# SERVICE BULLETIN

ENGINE FUEL AND CONTROL – FUEL SYSTEM AIR TUBE – INTRODUCTION OF PB SENSE LINE

V2500 Series 73-0246

The purpose of this Service Bulletin is to introduce a redesign of the Burner to EEC tube assembly, to be referred to as Pb sense line assembly, and provide rework instructions.

CONFIGURATION OF PB SENSE LINE  
FIGURE 1

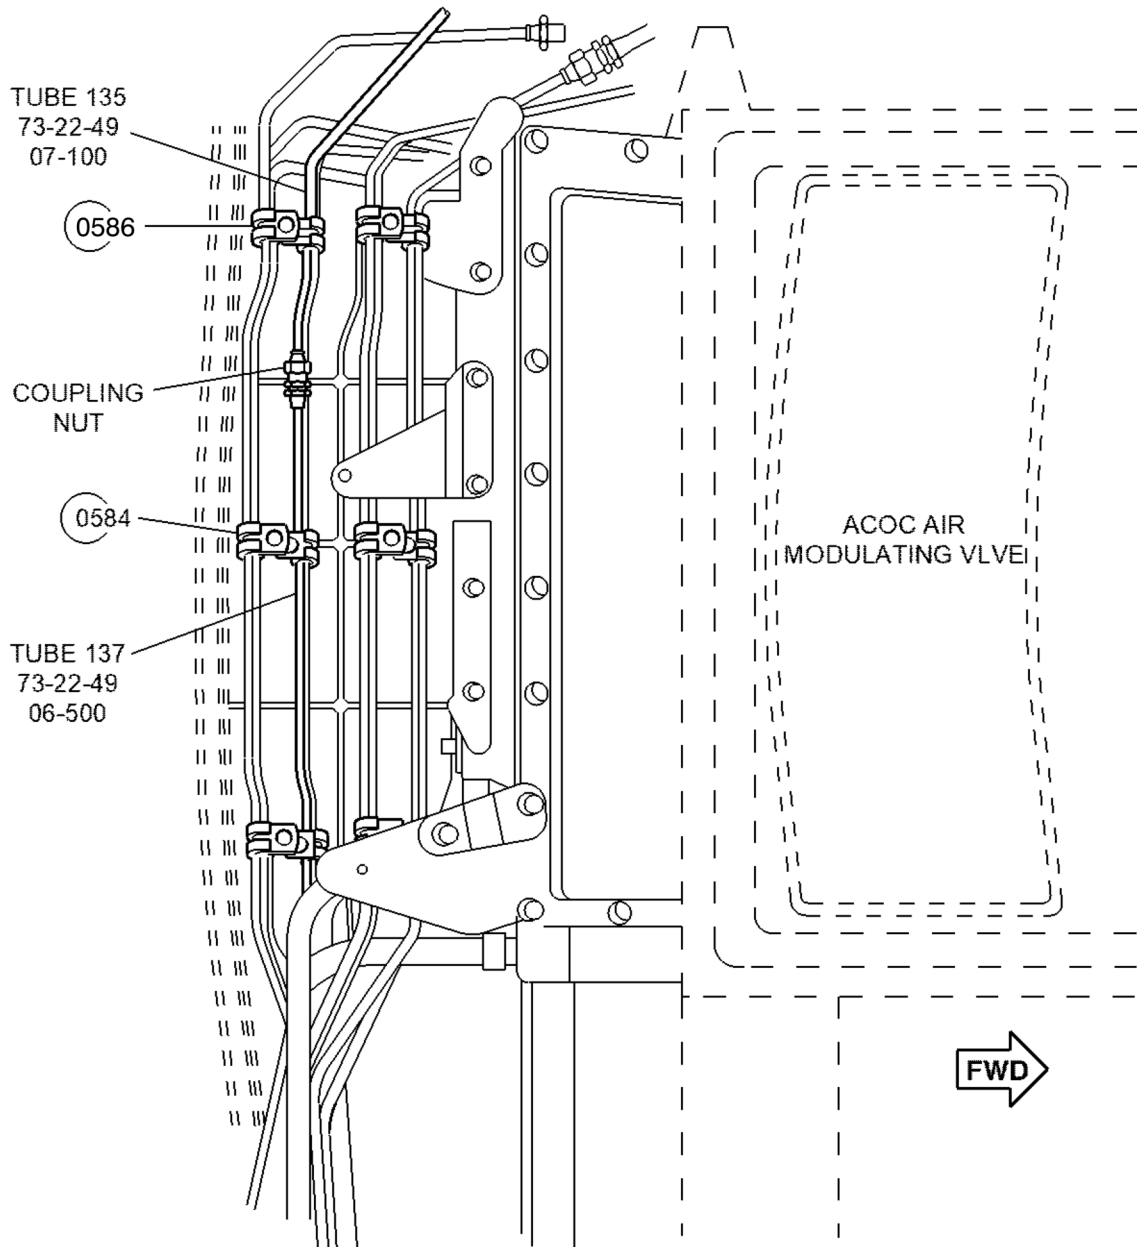
1. Remove the Pb Sense Line, PN 6A9039 (73-22-49, 07-100). See Figures 1 and 2.
  - A. Remove the bolts, the washers, the nuts and the clips at the CP1482, CP1481, CP1017, and CP0586. CP1482 hardware not needed for install.
  - B. Disconnect the Pb Sense Line, PN 6A9039 (73-22-49, 07-100) from the Tube Assembly, PN 6A9045 (73-22-49, 06-500).
  - C. Disconnect the Pb Sense Line, PN 6A9039 (73-22-49, 07-100) from P3 Union, PN 5A8234 (72-22-34, 01-270) at the EEC, remove the PN 6A9039 from engine.
  - D. Remove the Bracket, PN 6A9098 (73-22-49, 03-848). Bracket not needed for install.
2. Install the Pb Sense Line, PN 6M1250 (73-22-49, 01-100). See Figure 4 and 5.

- 1. Open the fan cowl doors (Refer to Reference 6, Aircraft Maintenance Manual (AMM), Chapter/Section 71-13-00).
- 2. Remove the Pb Sense Line, PN 6A9039 (73-22-49, 07-100). See Figures 1 and 2.
  - A. Remove the bolts, the washers, the nuts and the clips at the CP1482, CP1481, CP1017 and CP0586. CP1482 hardware not needed for install.
  - B. Disconnect the Pb Sense Line, PN 6A9039 (73-22-49, 07-100) from the Tube, PN 6A9045 (73-22-49, 06-500).
  - C. Disconnect the Pb Sense Line, PN 6A9039 (73-22-49, 07-100) from P3 Union, PN 5A8234 (72-22-34, 01-270) at the EEC, remove the Tube, PN 6A9039 from engine.
  - D. Remove the Bracket, PN 6A9098 (73-22-49, 03-848). Bracket not needed for install.
- 3. Install the Pb Sense Line, PN 6M1250 (73-22-49, 01-100). See Figure 4 and 5.

INSTALLATION OF PB SENSE LINE FLEX TUBE (73-22-49, 07-500)  
FIGURE 3

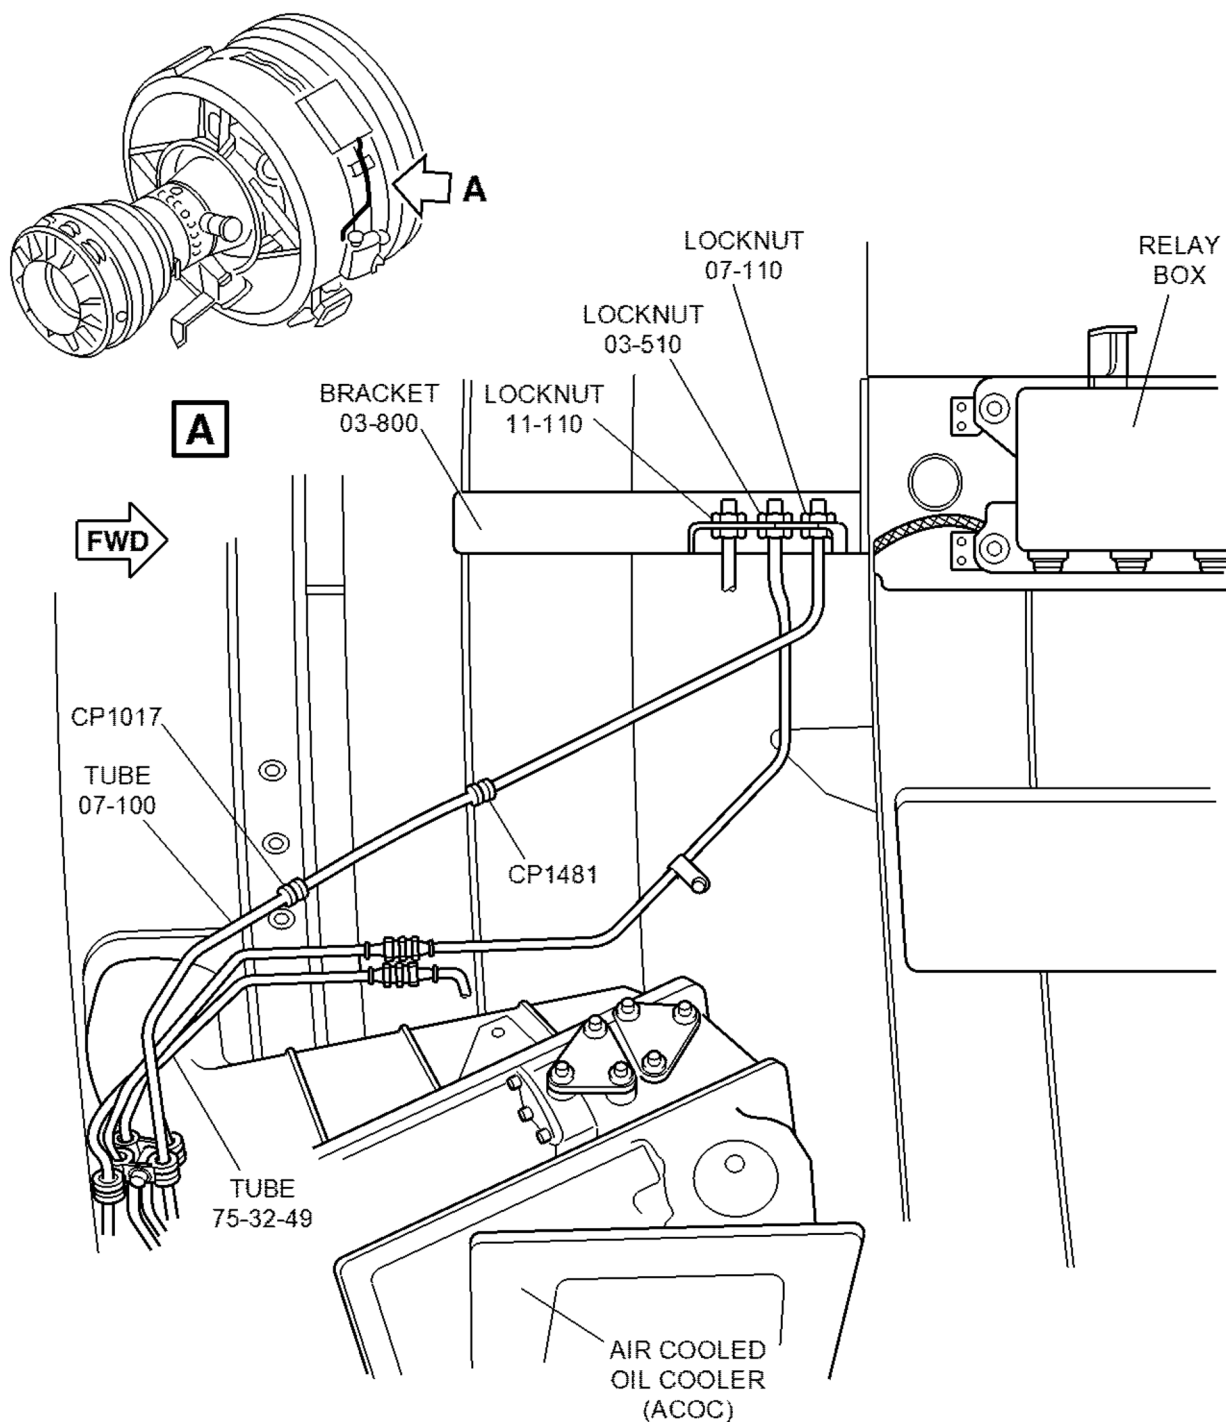
- D. Torque the nuts at the Clipping Positions CP1017, CP1481 and CP0586 to 36 to 45 lbf-in (4 to 5 N.m).
4. Install the Flex Tube, PN 44456 or 6M1262 (73-22-49, 07-500). See Figures 3.

- A. Connect the Flex Tube, PN 44456 or 6M1262 (73-22-49, 07-500) to the Pb Sense Line, PN 6M1250, fingertight.

NOTE: Ensure extended neck of the flex tube is installed facing down.

- B. Connect the Flex Tube, PN 44456 or 6M1262 (73-22-49, 07-500) to EEC Union, PN 5A8234 (72-22-34, 01-270), fingertight.
- C. Torque the Nuts on both ends of the Flex Tube, PN 44456 or 6M1262 (73-22-49, 07-500) to 142 to 150 lbf-in (16 to 17 N.m).
- D. Safety the locking nut, the coupling nut and the flex tube nut with CoMat 02-126 Lockwire.

INSTALLATION OF PB SENSE LINE TUBE 6M1250  
FIGURE 4

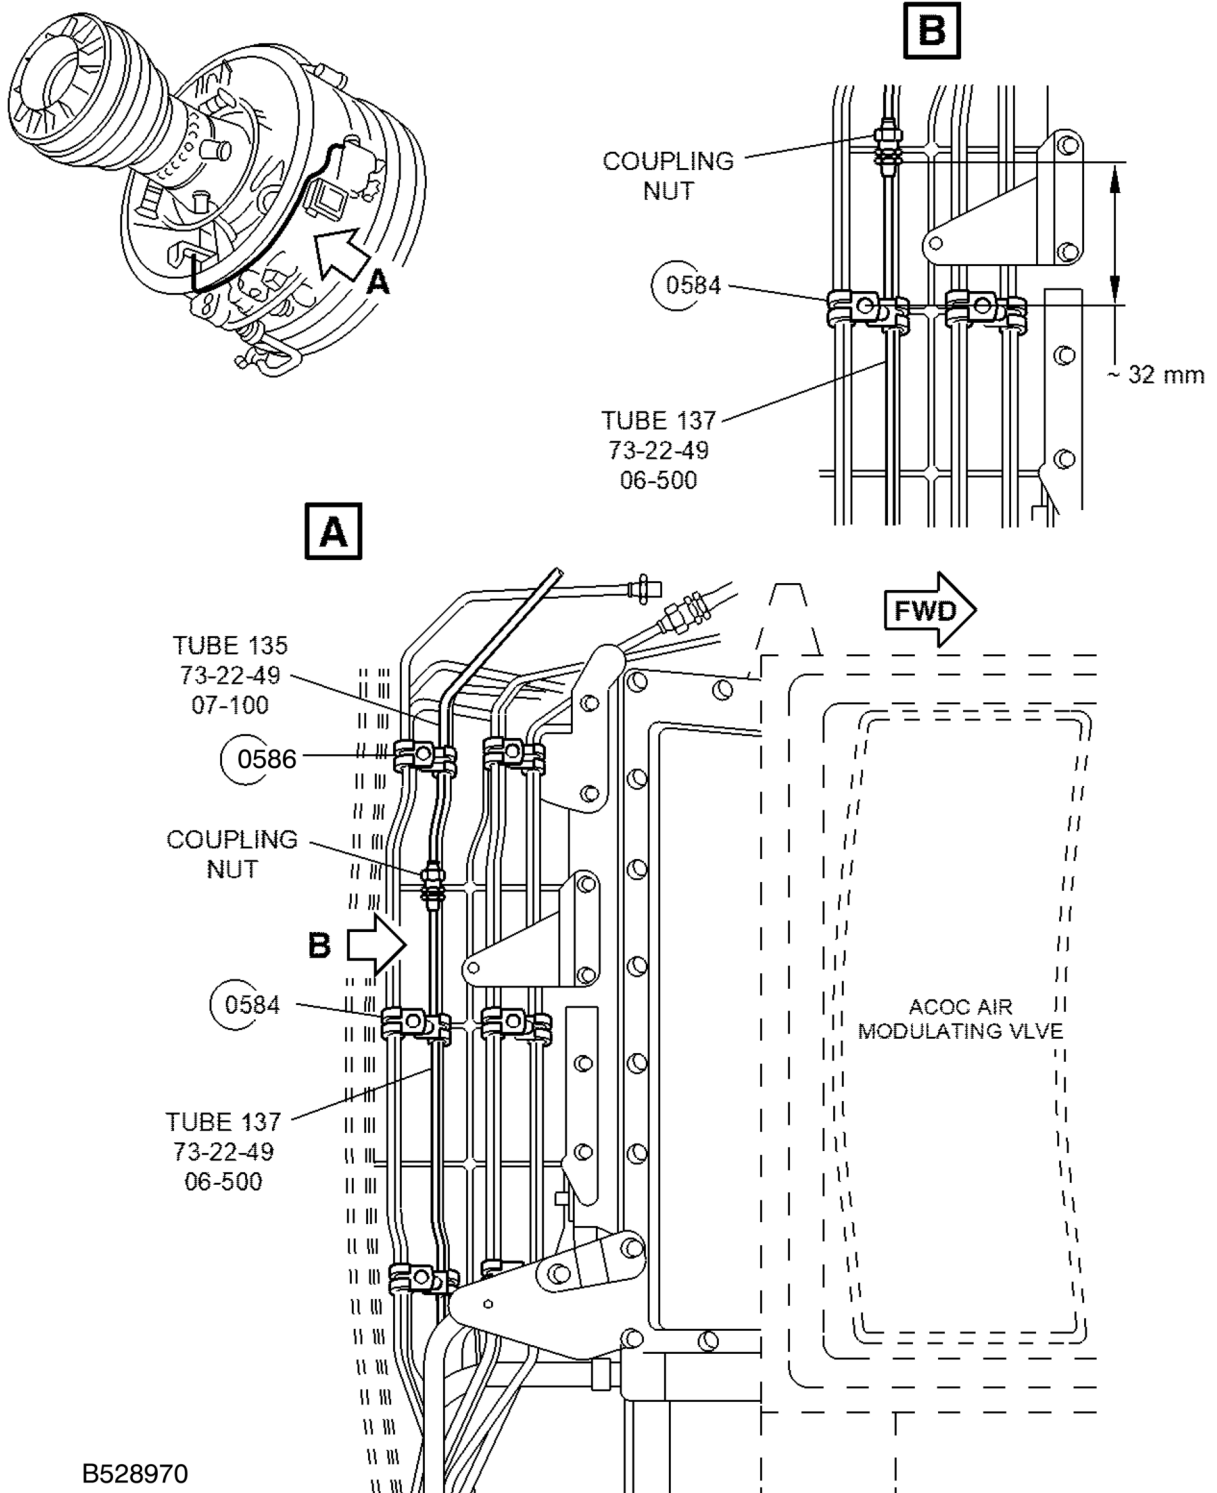
- A. Install the Pb Sense Line, PN 6M1250 (73-22-49, 07-100) to the Bracket PN 6A9096 (73-22-49, 03-800) with the Locknut, PN MS9201-04 (73-22-49, 07-110), fingertight.

- B. Connect the Pb Sense Line, PN 6M1250 (73-22-49, 07-100) to the Tube Assembly, PN 6A9045 (73-22-49, 06-500). Fingertight.
  - C. Torque the Locknut, PN MS9201-04 (73-22-49, 07-110) to 38 to 42 lbf-in (4.3 to 4.7 N.m).

- D. Torque the Coupling Nuts between the Pb Sense Line, PN 6M1250 (73-22-49, 07-100) and Tube Assembly, PN 6A9045 (73-22-49, 06-500) to 159 to 177 lbf-in (17 to 20 N.m).

INSTALLATION OF PB SENSE LINE TUBE LOWER MOUNTING  
FIGURE 5

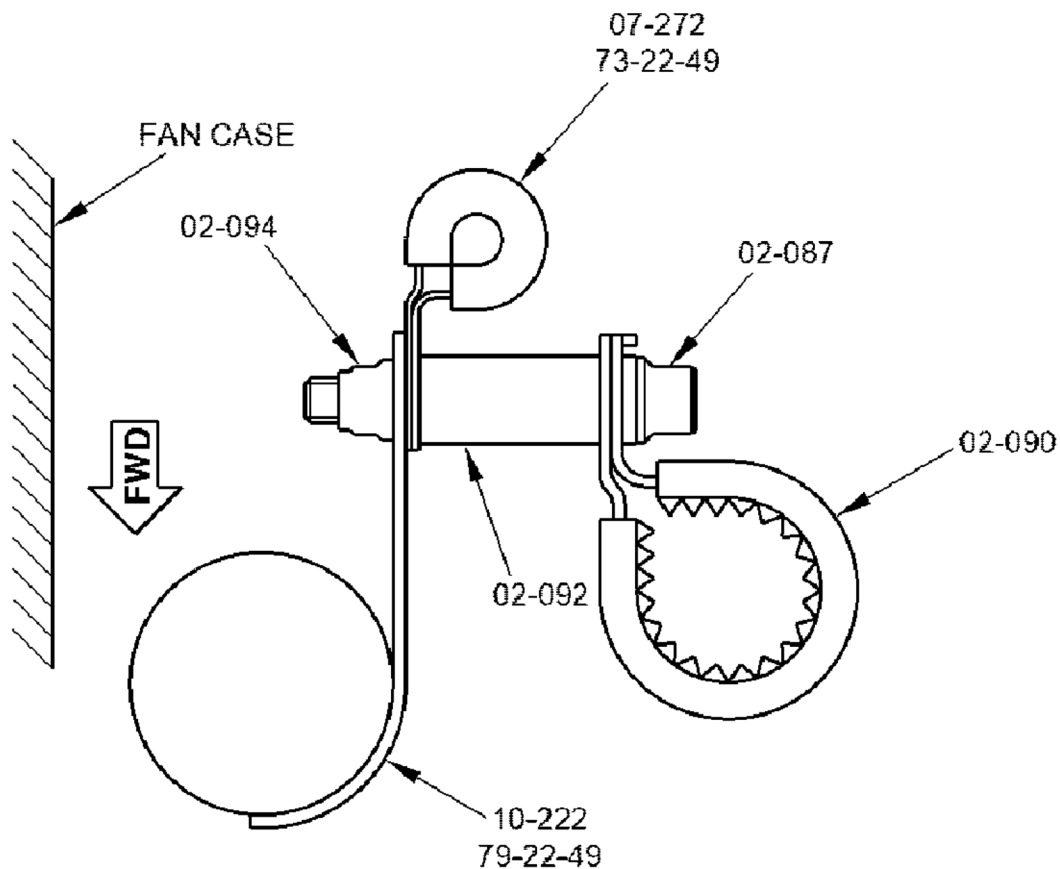
NOTE: To maintain an ideal fit, install top end of the Tube Assembly, PN 6A9045 (73-22-49, 06-500) connector flange to approximately 1.25 in (32 mm) from the center of CP0584. See Figure 5.

**CAUTION:** IF CLEARANCE IN CP1481 IS NOT SUFFICIENT OR CONTACT APPEARS BETWEEN THE TUBE, PN 6M1250 (73-22-49, 07-100) AND THE BRACKET, PN 5W8351 (73-22-49, 07-800). SEE FIGURE 5. ADJUSTMENT OF PROPER CLEARANCE IS NECESSARY. TO ADJUST DISTANCE BETWEEN THE TUBE AND THE BRACKET LOOSEN THE BOLTS PN 4W1064 (73-22-49, 07-801). SET PROPER DISTANCE 0.05 IN (1.3 MM) MIN AND TORQUE THE NUTS TO 85 -105 LBF-IN (9.6 - 11.9 N.M).

CLIP POSITION CP1017  
FIGURE 6

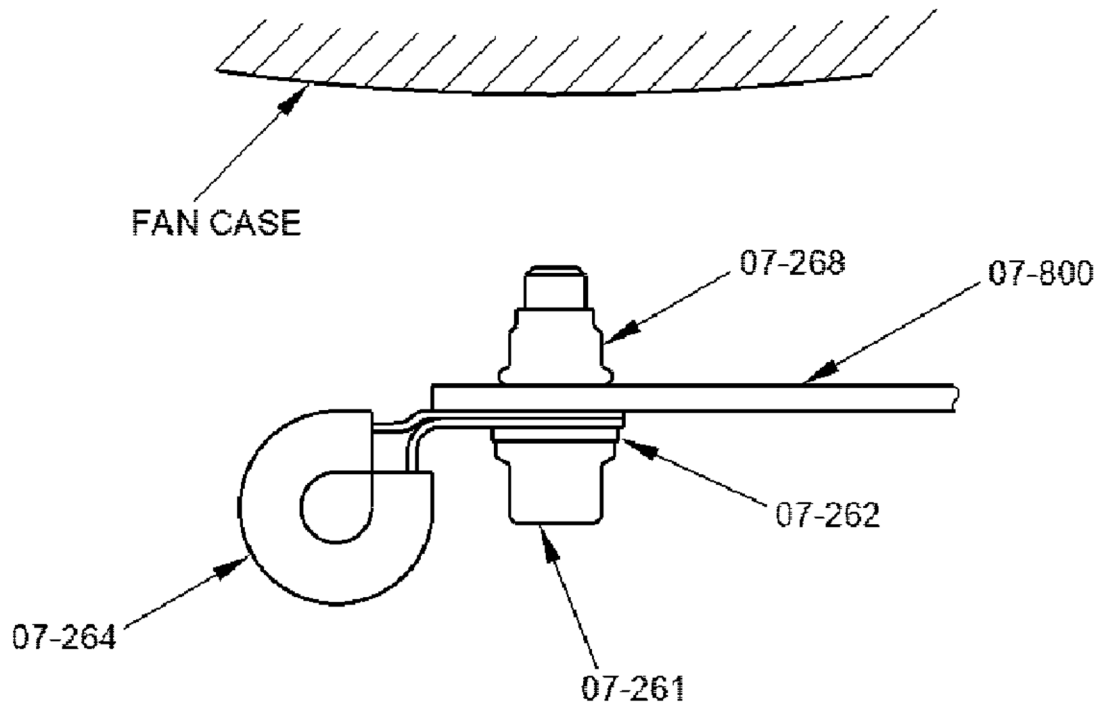
- B. Install the Bolt, PN 4W0357 (71-51-41, 02-087), the Clip, PN AS62213 (71-51-41, 02-090), the Spacer, PN 5W1032 (71-51-41, 02-092), the Clip, PN AS62406 (73-22-49, 07-272) and the Nut, PN 4W0001 (71-51-41, 02-094) at the CP1017, fingertight.

CLIP POSITION 1481  
FIGURE 7

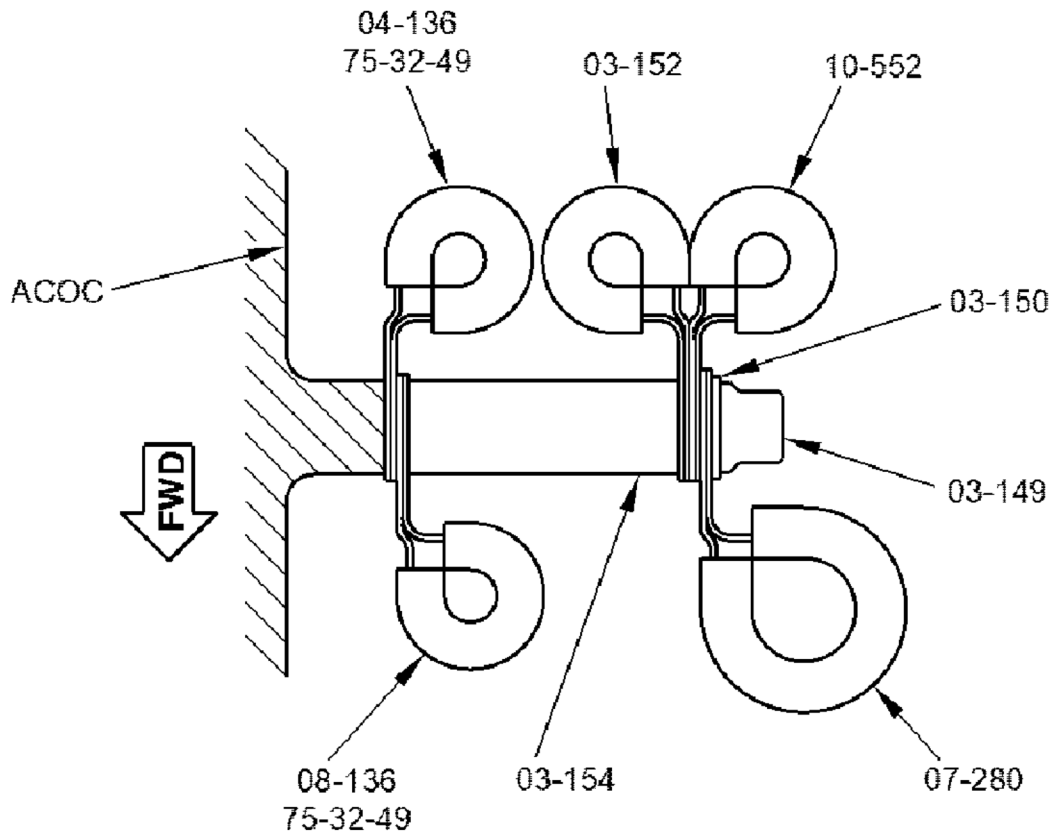
3. Install the Clipping Positions CP1017, CP1481 and CP0586. See Figures 6, 7, and 8.
  - A. Install the Bolt, PN 4W0342 (73-22-49, 07-261), the Washer, PN K8831 (73-22-49, 07-262), the Clip, PN AS62406 (73-22-49, 07-264) and the Nut, PN 4W0001 (73-22-49, 07-268) at the CP1481, fingertight.

CLIP POSITION CP0586  
FIGURE 8

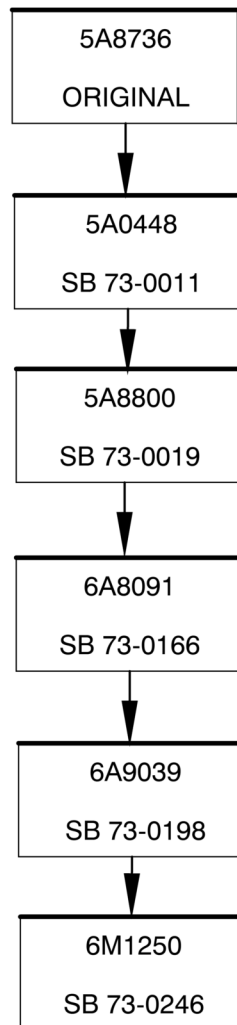
- C. Install the Bolt, PN 4W0363 (73-22-49, 03-149), the Washer, PN K8831 (73-22-49, 03-150), the Clip, PN AS62406 (73-22-49, 07-280), the Clip, PN AS62404 (73-22-49, 10-552), the Clip, PN AS62404 (73-22-49, 03-152), the Spacer, PN 5W1032 (73-22-49, 03-154), the Clip PN AS62404 (75-32-49, 08-136) and the Clip, PN AS62404 (75-32-49, 04-136) at the CP0586, fingertight.

73-22-49-07-500  
Flex Tube

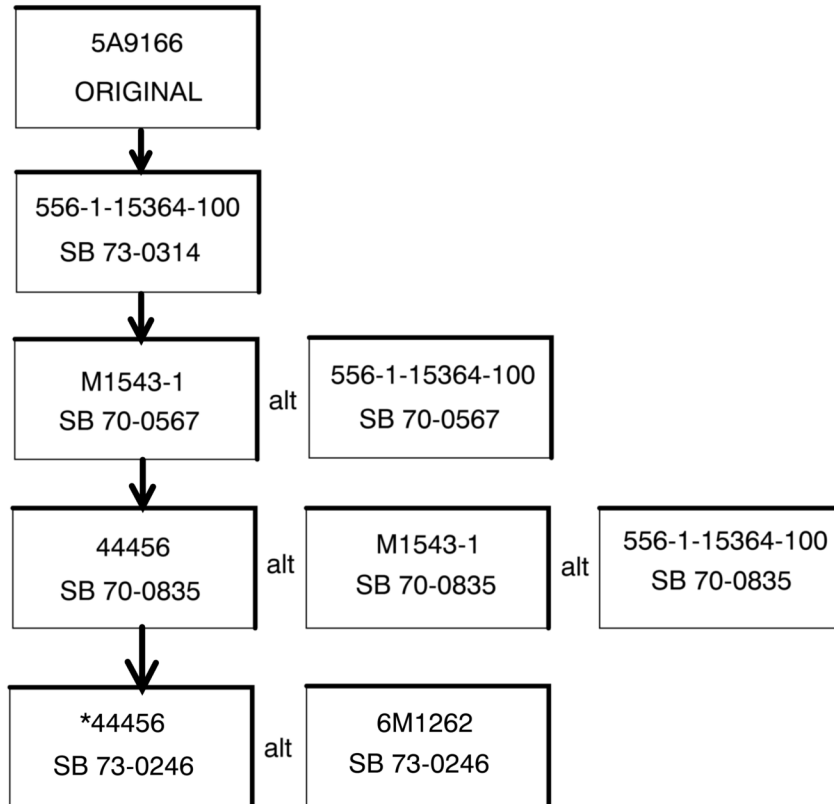
\*M1543-1 AND 556-1-15364-100 no longer alternatives to 44456 in post 73-0246 configurations.
